Re: PA Ops - State Antelope 31-34-16HNB (05-123-37404)

Subject: PA Ops - State Antelope 31-34-16HNB (05-123-37404)

PROPOSED HZ PA WBD (Vertical-Deviated Schematic)							Reference Wells			
Well Name STATE ANTELOPE 31-34-16HNB		API # 0512337404	Operator BONANZA CREEK ENERGY OPERATING		State COLORADO		County/Parish WELD		Type Water Well	Commer 202'
Quarter 1 NW		Quarter 2 NE		Section 16	Township 5	Township N/S Dir N	Range 62	Range EW Dir W	Type Fox Hills	Commer 255'
									Type UPA	Commer 1413'

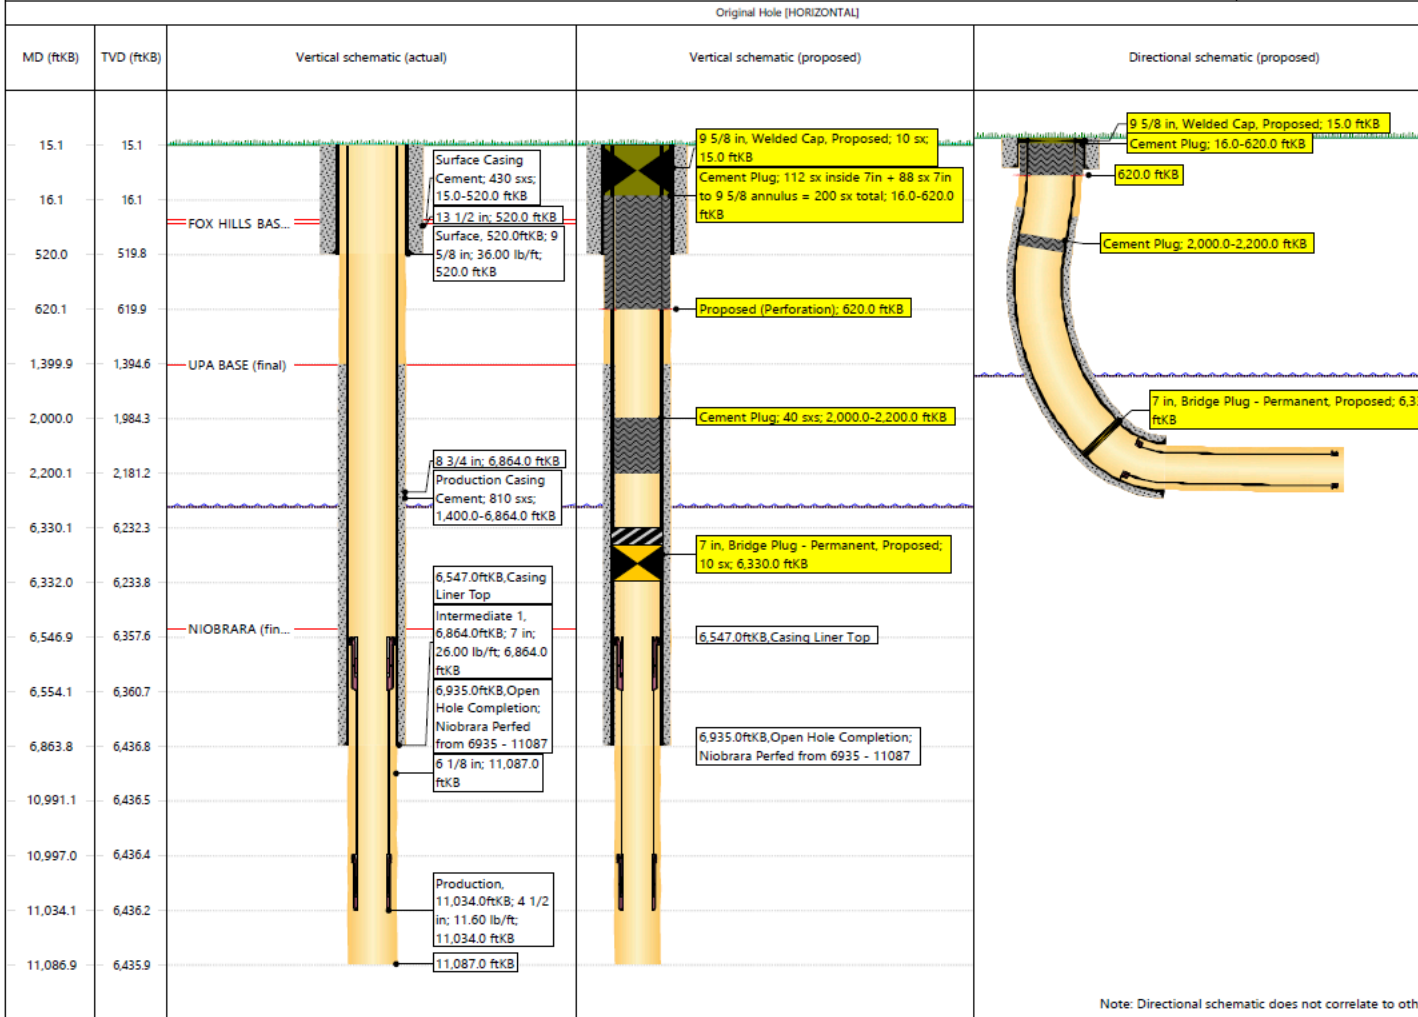
- Ran Bridge plug + cement
- Finished running RBL
- Initial plan was to set plug at 2200-2000, and perf circ cement to surface in/out at 620'
- CBL shows good cement to 230'

- Set plug inside 7" casing - 100' below surface shoe to surface (620' to surface inside 7")
- Place 10sx on 7" annulus

We still need that plug at 2200' for the mid range plug. I am good with casing plug for the shoe plug rather than perforating.

Yeah the 2000'-2200' will stay.
Thank you,

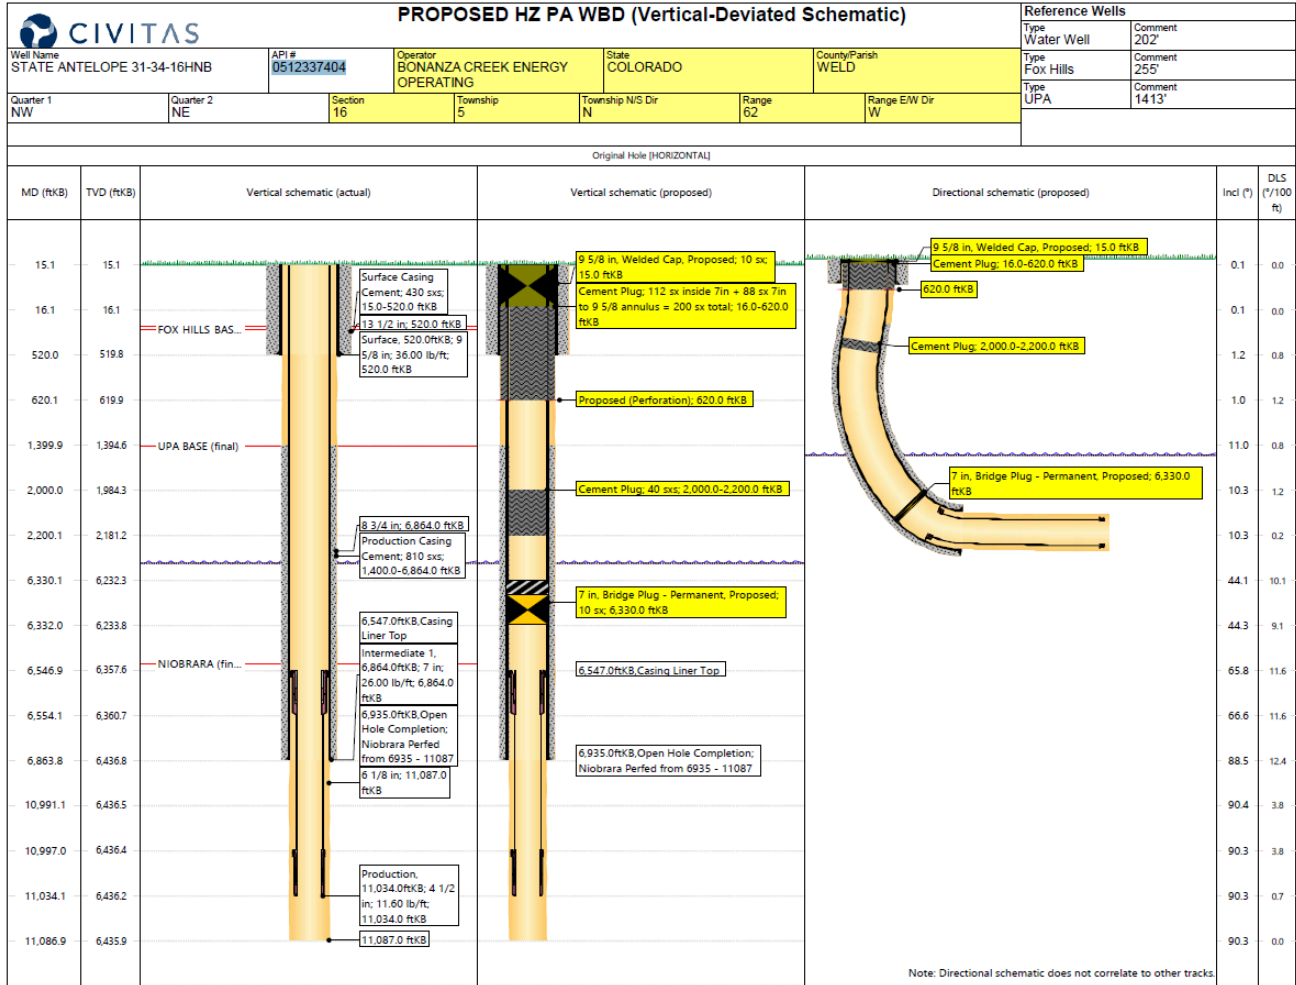
- Ran Bridge plug + cement
- Finished running RBL
- Initial plan was to set plug at 2200-2000, and perf circ cement to surface in/out at 620'
- CBL shows good cement to 230'

- Set plug inside 7" casing - 100' below surface shoe to surface(620' to surface inside 7")
- Place 10sx on 7" annulus
